**CITY OF TEMPE
DEVELOPMENT REVIEW COMMISSION**

Meeting Date: 06/23/2015

ACTION: Request for a Zoning Map Amendment from R-2 Multi-Family to R1-PAD Single-Family, a Planned Area Development to establish development standards and a Development Plan Review for a seven unit townhome development for FIFTH STREET WEST 10, located at 1214 W 5TH Street. The applicant is Tom Goscicki.

ZON15002 AND PAD15008

DEV. PLAN REVIEW ARCHITECTURAL SITE PLAN

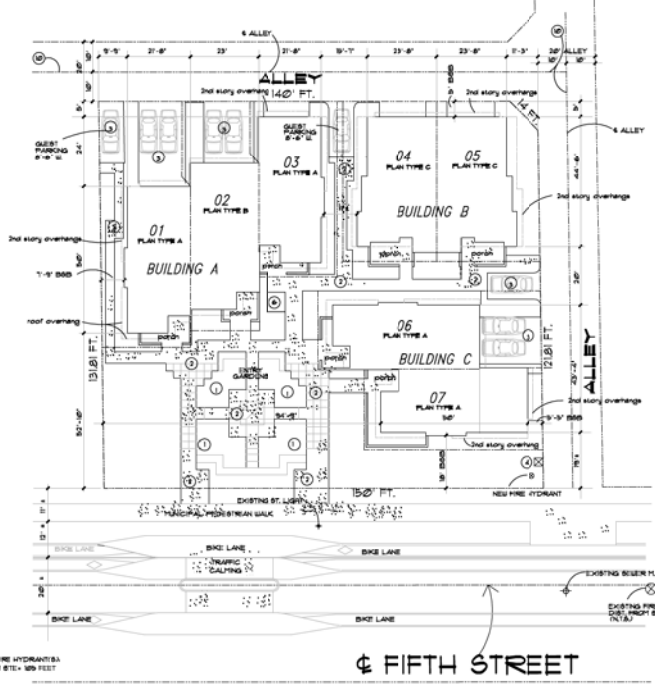
1. The site plan is approved as submitted June 5, 2015, minor modifications may be reviewed through the plan check process of construction documents; major modifications will require submittal of a Development Plan Review.
2. Verify height of equipment and mounting base to ensure that parapet or screen wall height is adequate to fully screen the equipment. Locate electrical service entrance sections on alley side of units.
3. Utility equipment boxes for this development shall be finished in a neutral color (subject to utility provider approval) that compliments the coloring of the buildings.

5 SOUTH ELEV BUILDING A

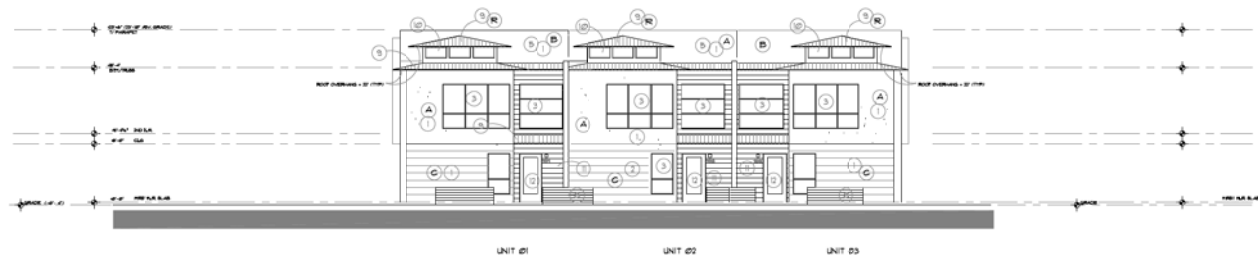
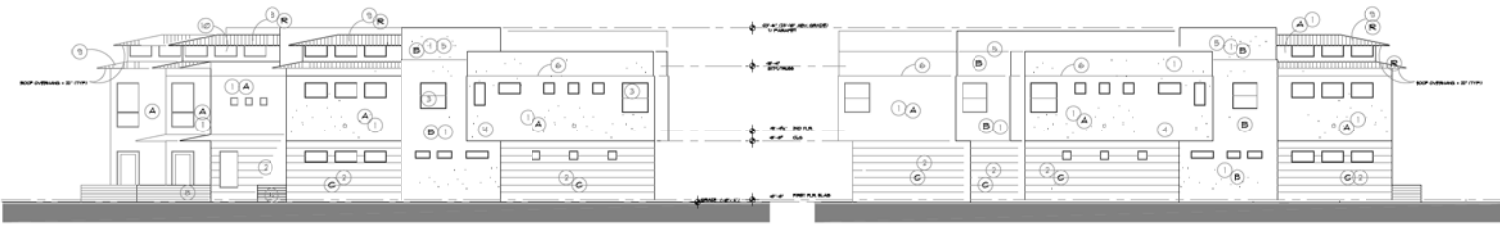
4. The materials and colors are approved as presented (June 5, 2015):
 - Roof – parapet and standing seam (satin black finish)
 - Primary Building – Sand finished stucco painted Behr Navajo White 22 (creamy white)

- Secondary Building – Sand finished stucco painted Behr S260-3 Dusty Gold (light tan)
 - Tertiary Building – Sand finished stucco painted Behr P200-5 Garden Salt Green (medium olive green)

- Stucco panel sections use elastomeric 1 coat stucco with sand finish has metal U Channels to define sections
 - Cement Board Siding – Hardy Board 8” Lap wood finish siding painted Behr S190-6 Rio Rust (rust/copper)

- Doors – solid core wood painted Dunn Edwards P200-5 Burning Coals (bright orange) with dual paned frosted glass inset
 - Bedroom Door accessed from patio to be painted to match wall adjacent to door, to differentiate the front door from the bedroom door.

- Patio Canopies – metal painted structural steel, Dunn Edwards DEA186 Black Pearl (black)
 - Patio canopies shall be deep enough to shelter both front and bedroom doors, and a portion of the front patio.

- Windows - Anodized aluminum black frame with clear low-e glazing
 - Garage Doors – overhead 5 section metal garage door painted to match adjacent wall color

- Masonry Porch Walls 8"x4"x16" hollow brick units, Phoenix Brick Yard, Ladrillo Grande (dark charcoal grey) with velour texture
 - Provide primary building colors and materials with a light reflectance value of 75 percent or less. Specific colors and materials exhibited on the materials sample board are approved by planning staff. Additions or modifications may be submitted for review during building plan check process.

Preliminary Planting Plan

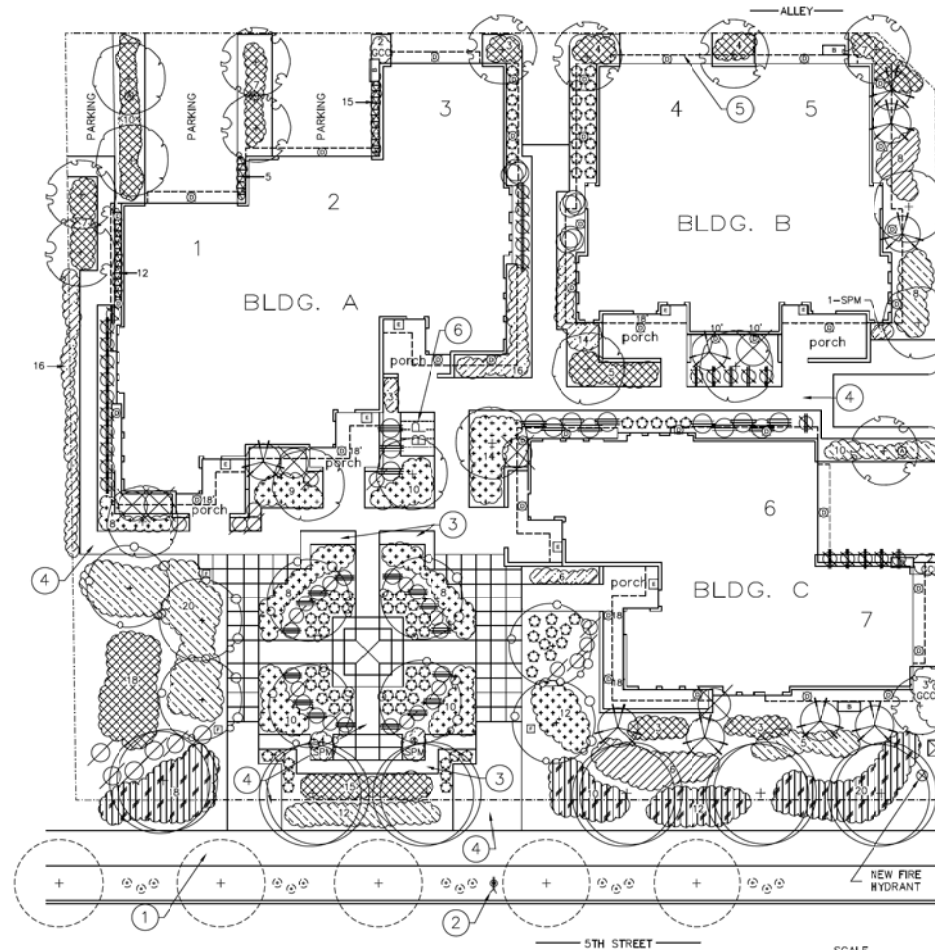
8. The plant palette is approved as proposed and specified on the landscape plan submitted June 5, 2015, with the following exceptions:
 - a. Trees along the street frontage shall be a minimum of 1 ½" caliper and 36" box
 - b. Trees along the alley and west perimeter shall be a minimum of 1 ½" caliper.
 - c. Justicia Candicans was indicated twice on the landscape plan, substitute Justicia Spicigera for the second plant of this species that was specified.

9. Place exterior, freestanding reduced pressure and double check backflow assemblies in pre-manufactured, pre-finished, lockable cages (one assembly per cage). If backflow prevention or similar device is for a 3" or greater water line, delete cage and provide a masonry or concrete screen wall following the requirements of Standard Detail T-214.

10. Irrigation notes:
 - a. Provide dedicated landscape water meter.
 - b. Provide pipe distribution system of buried rigid (polyvinylchloride), not flexible (polyethylene). Use of schedule 40 PVC mainline and class 315 PVC ½" feeder line is acceptable. Class 200 PVC feeder line may be used for sizes greater than ½". Provide details of water distribution system.

11. Include requirement to de-compact soil in planting areas on site and in public right of way and remove construction debris from planting areas prior to landscape installation.

12. Top dress planting areas with a rock or decomposed granite application. Provide rock or decomposed granite of 2" uniform thickness. Provide pre-emergence weed control application and do not underlay rock or decomposed granite application with plastic.

13. Trees shall be planted a minimum of 20'-0" from any existing or proposed public water or sewer lines. The tree planting separation requirements may be reduced from the waterline upon the installation of a linear root barrier, a minimum of 6'-0" parallel from the waterline, or around the tree. The root barrier shall be a continuous material, a minimum of 0.08" thick, installed 0'-2" above finish grade to a depth of 8'-0" below grade. Final approval subject to determination by the Public Works, Water Utilities Division.
